**AGENDA**  
**CITY OF CEDAR FALLS, IOWA**  
**PLANNING AND ZONING COMMISSION MEETING**  
**WEDNESDAY, FEBRUARY 23, 2022**  
**5:30 PM AT CEDAR FALLS COMMUNITY CENTER, 528 MAIN STREET**

**TO:** Planning Commission  
**FROM:** Michelle Pezley, Planner III  
 Ben Claypool, Civil Engineer II, PhD, EI  
**DATE:** February 15, 2022  
**SUBJECT:** Commercial Site Plan – 3717 Midway Drive (Case # SP22-001)

**REQUEST:** Site plan approval for mini-storage units in C-2 Zoning District  
**PETITIONER:** Gordie Sorensen, Sorensen Real Estate Partners, Inc. (purchase agreement)  
**LOCATION:** 3717 Midway Drive; South of University Avenue; East of the City Limits.

Site Plan Review for Mini-Storage units  
3717 Midway Drive (SP22-001)

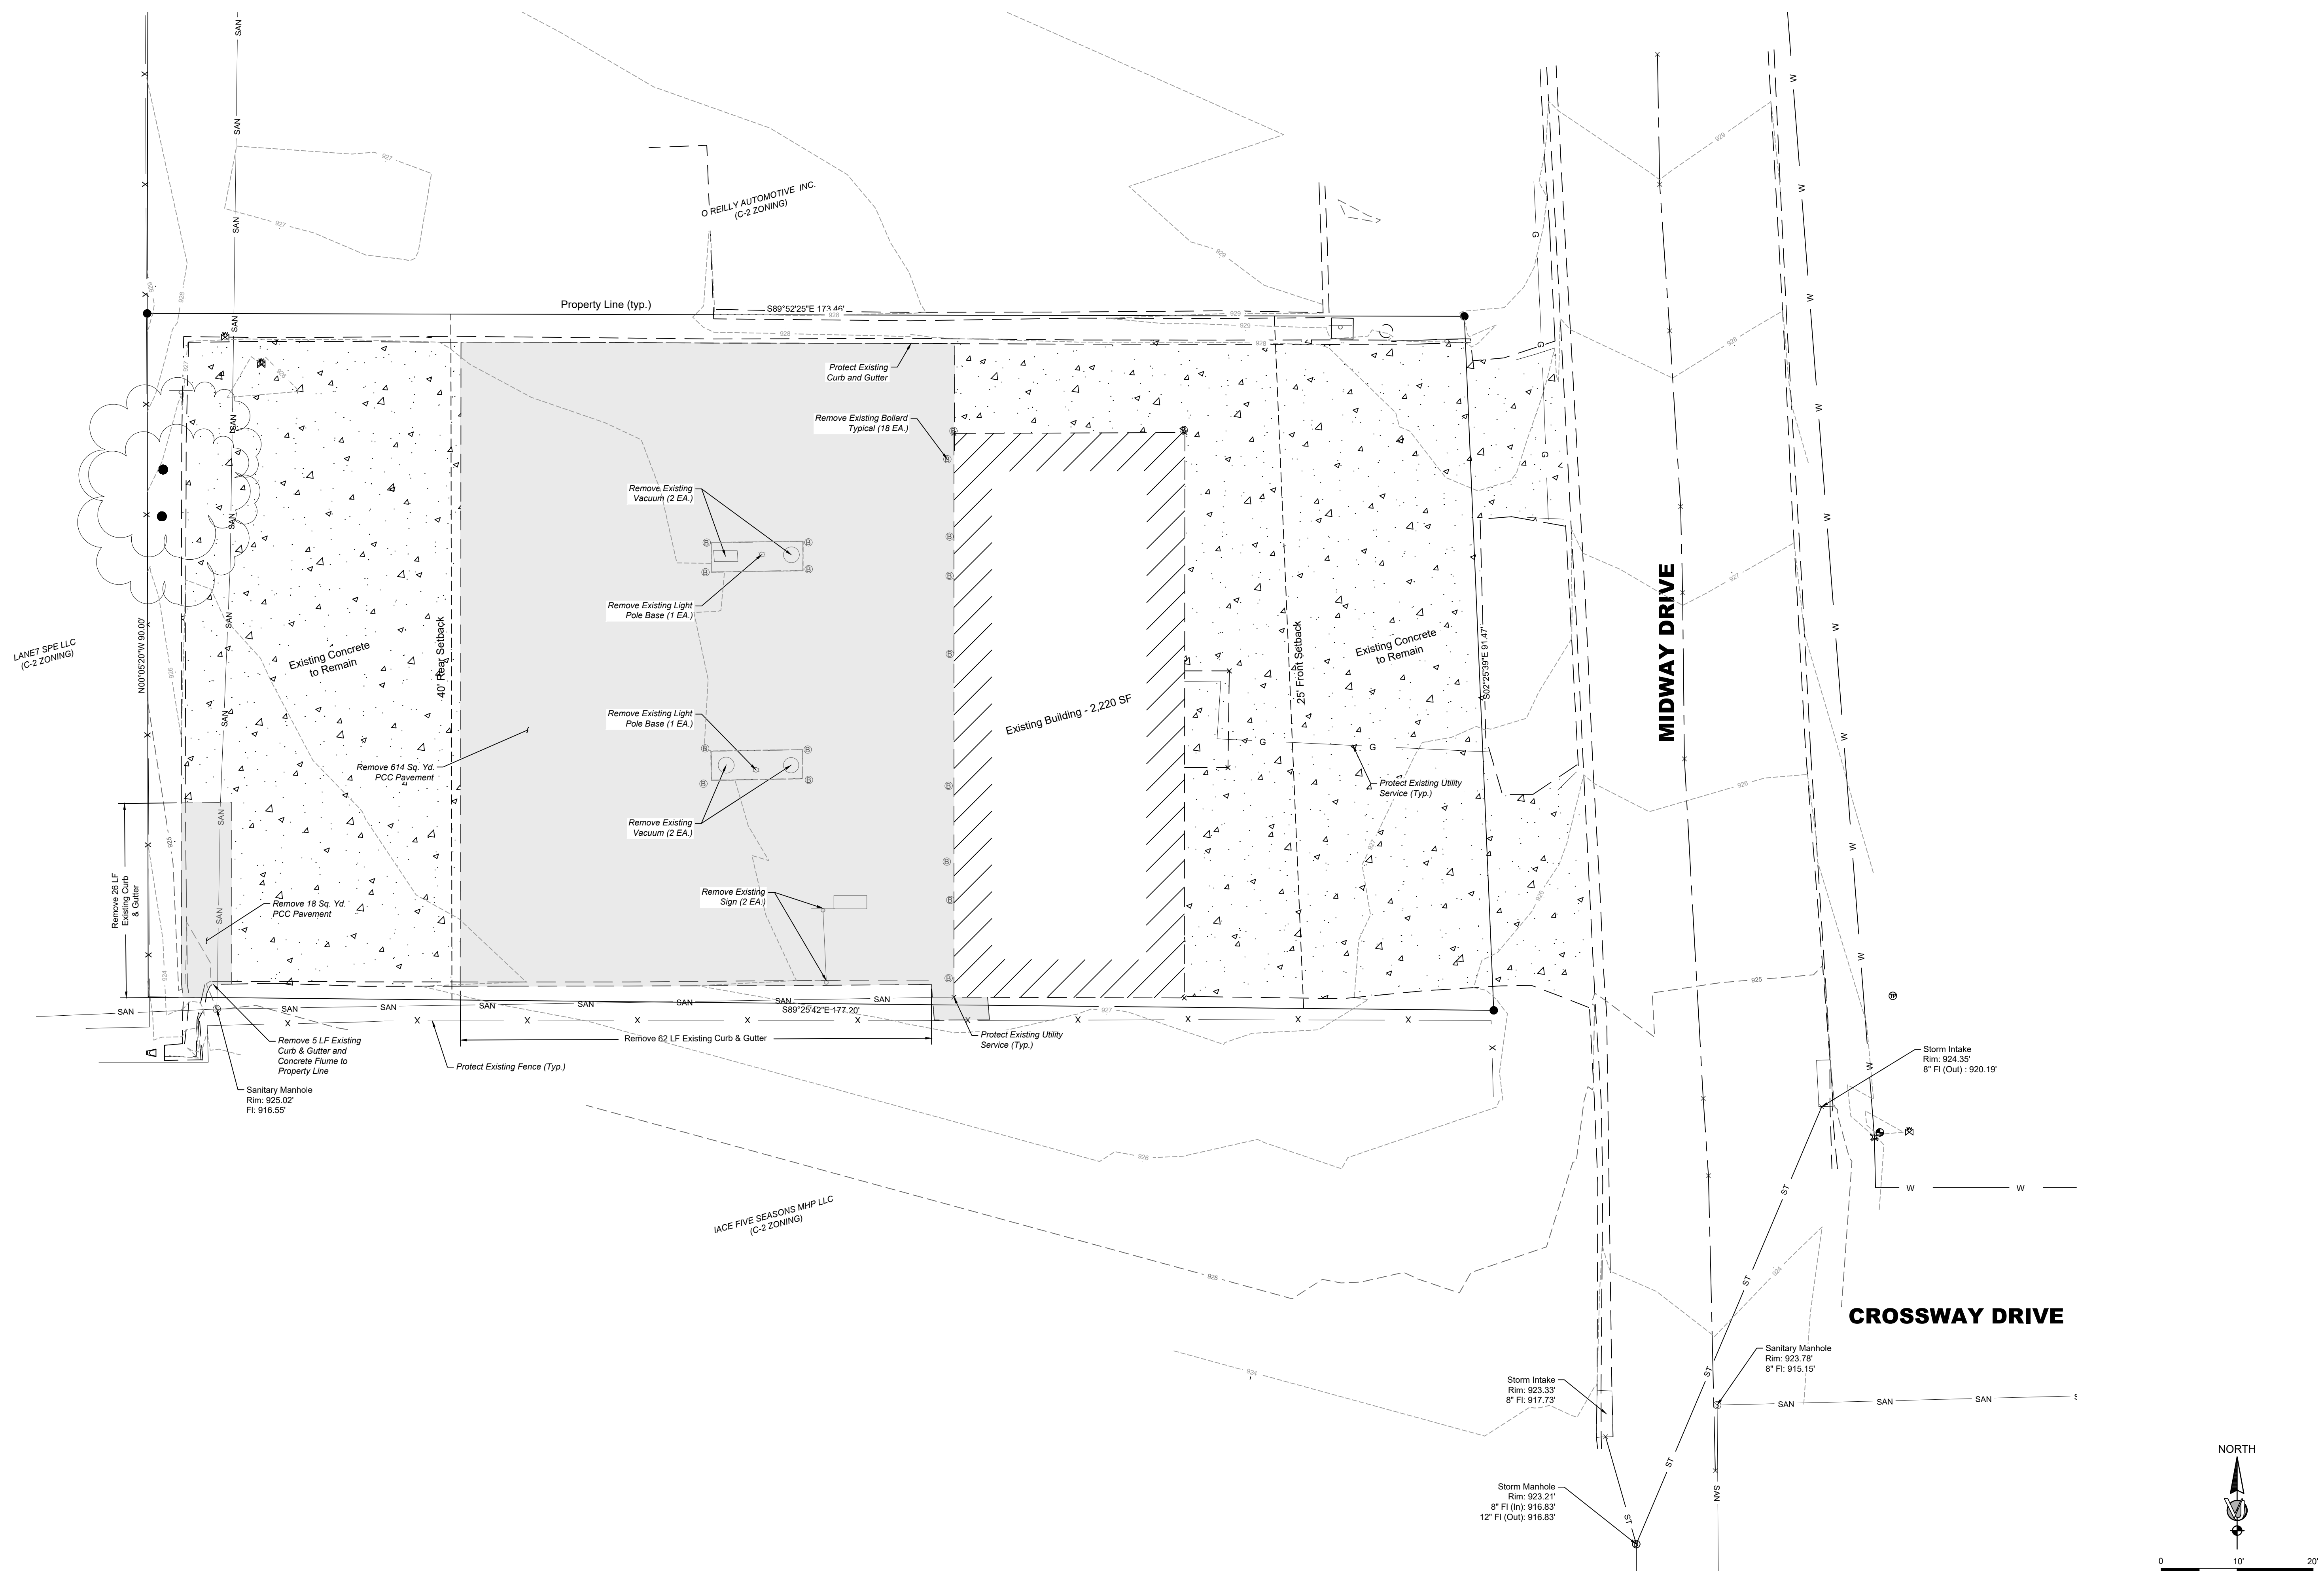
The applicant proposes the new addition to be 18 feet from the north (side) property line; two and a half feet from the south (side) property line, and approximately 56 feet from the rear (west) property line. The existing building is approximately 34 feet from the front (east) lot line.

The parking lot is required to be set back 5 feet from abutting properties; however, the applicant plans to use the existing non-conforming parking lot in the front of the building, which does not have a setback along the southern property line.

**Building setbacks are satisfied. The parking lot setbacks are nonconforming, but pre-existing.**

The parking meets the zoning standards with minimum stall dimensions of 9' x 19' as shown in the site plan. **The amount and dimension of the parking stalls and drives are met.**

SITE PLAN - LANDSCAPE LEGEND

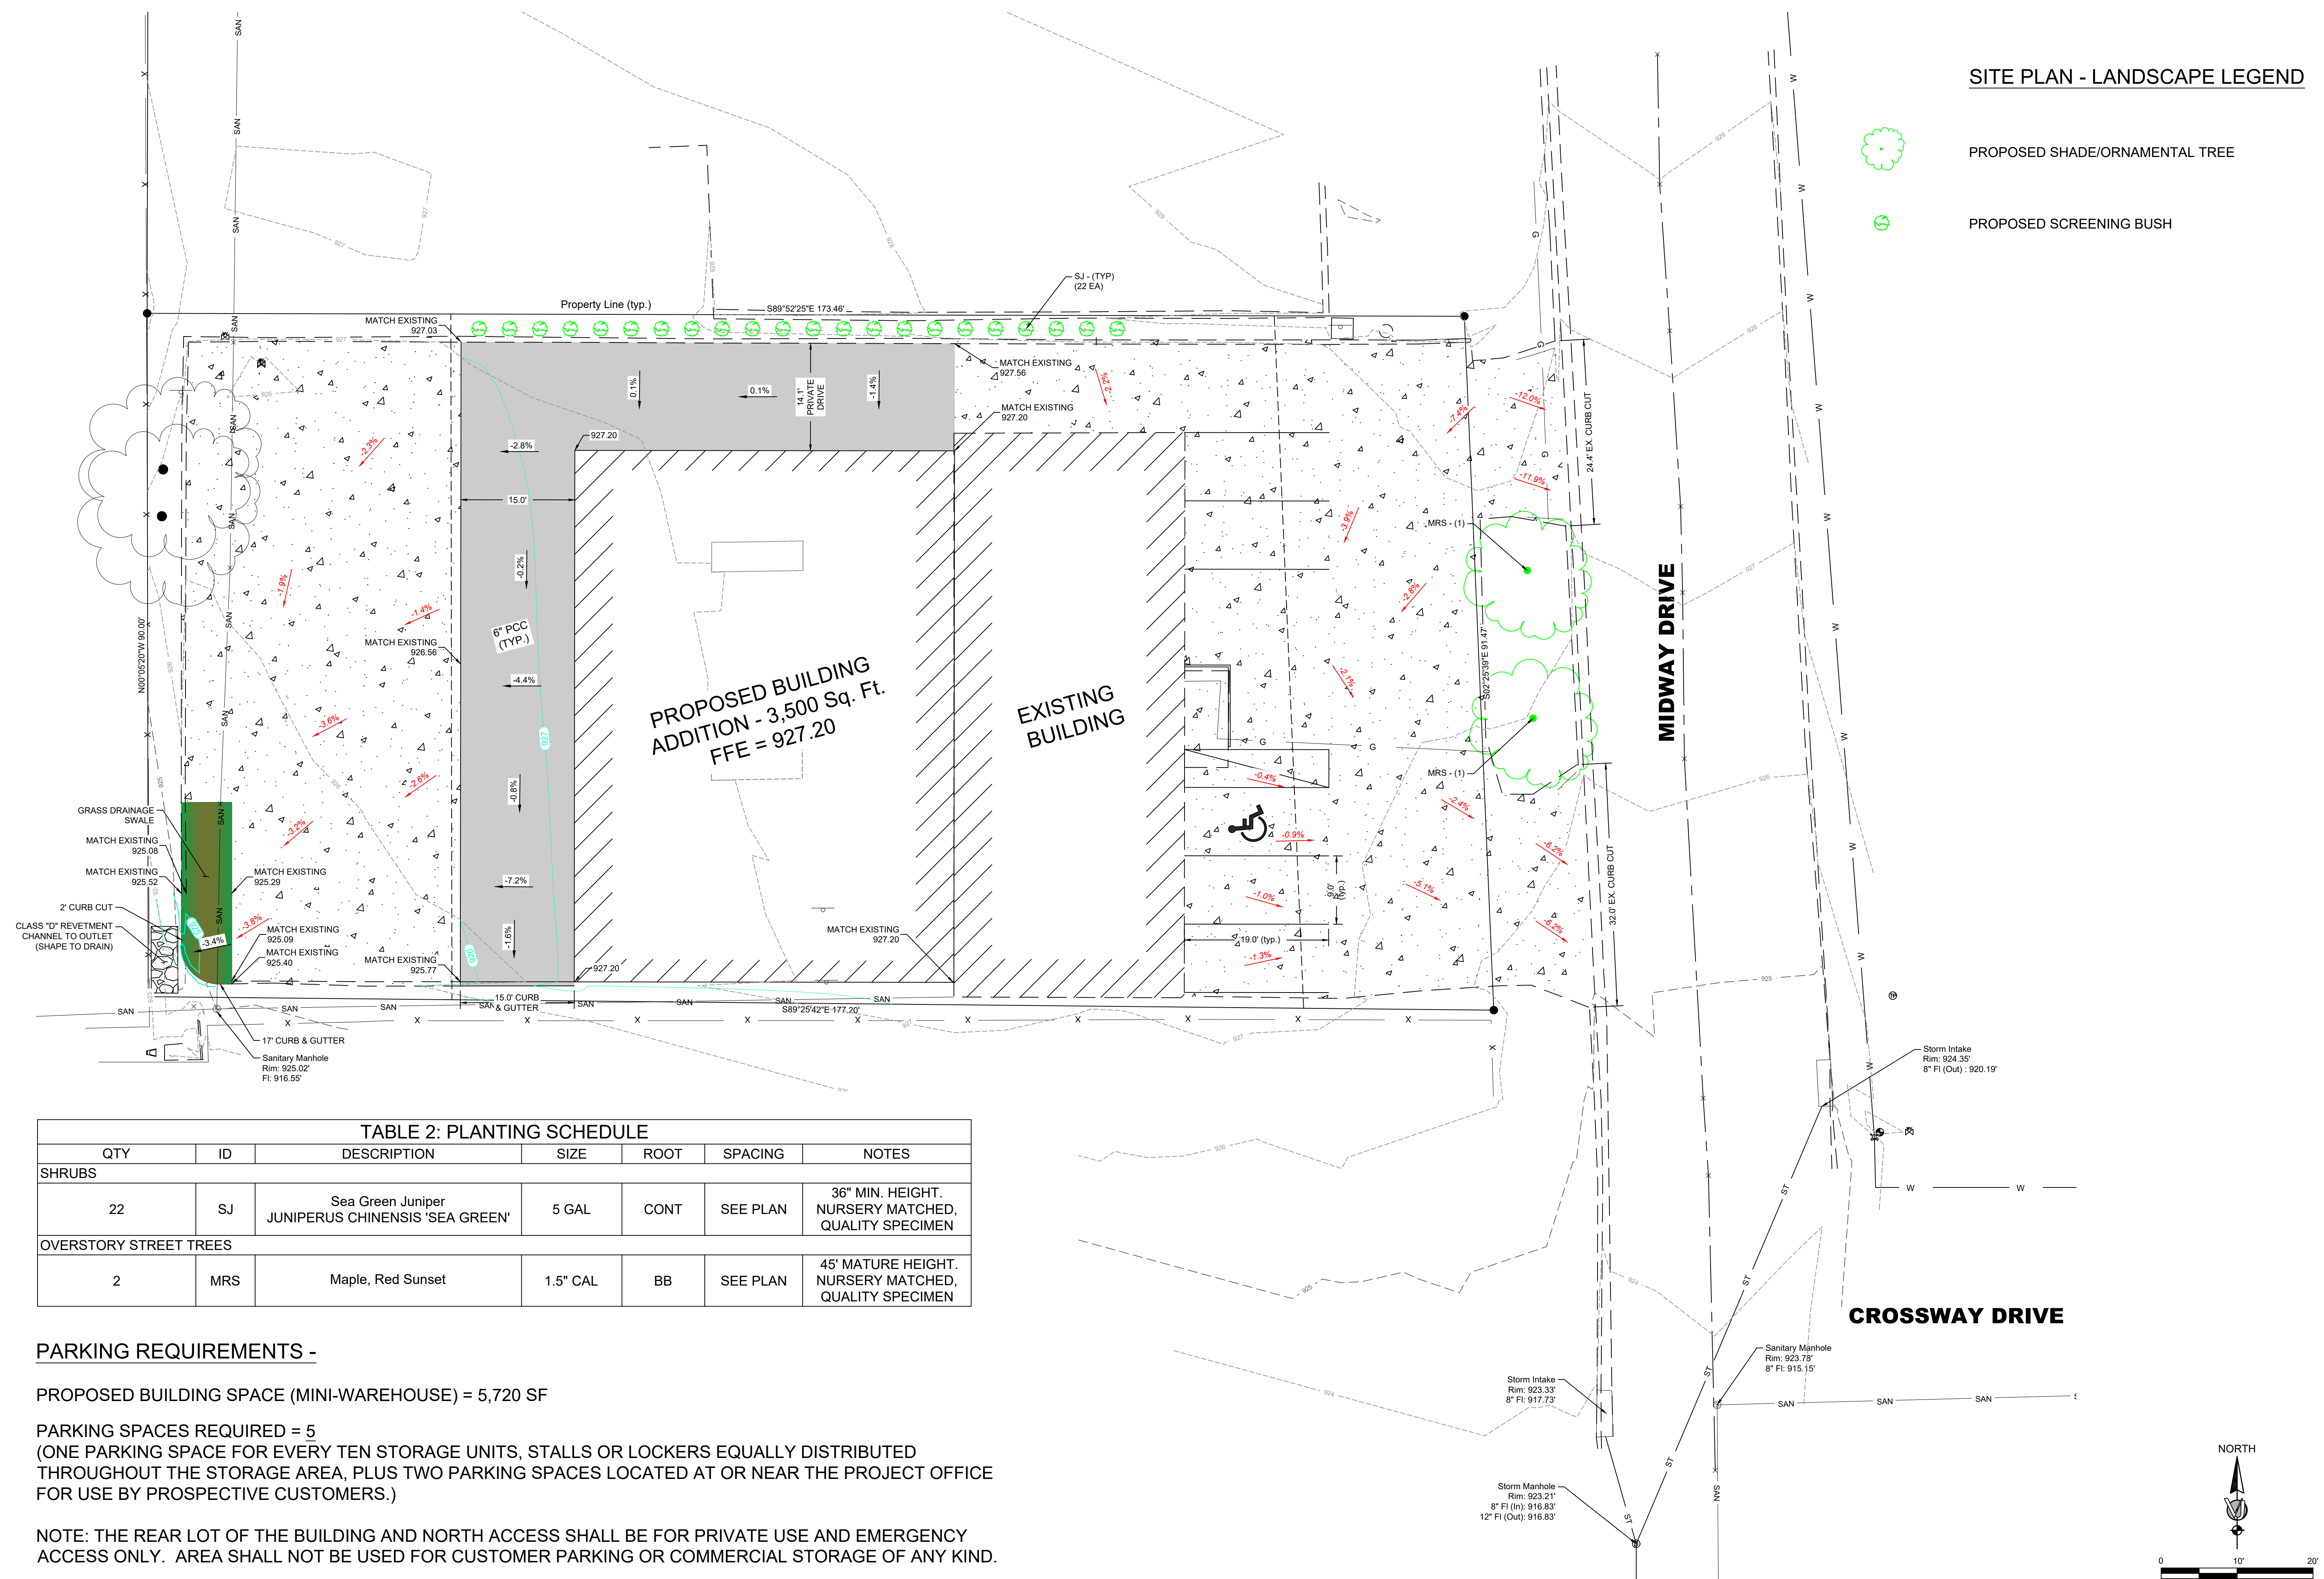
Currently, there are two trees on the property in the rear of the lot and landscape buffers with grass along the northern property lines. The applicant proposes to keep the existing non-conforming parking lot as is. The landscaping plan shows a row of

Sea Green Juniper bushes along the northern property line and two Red Sunset Maple trees in the right-of-way. **The landscaping plan meets the landscape screening and street tree requirements to the extent possible given the existing nonconformities.**
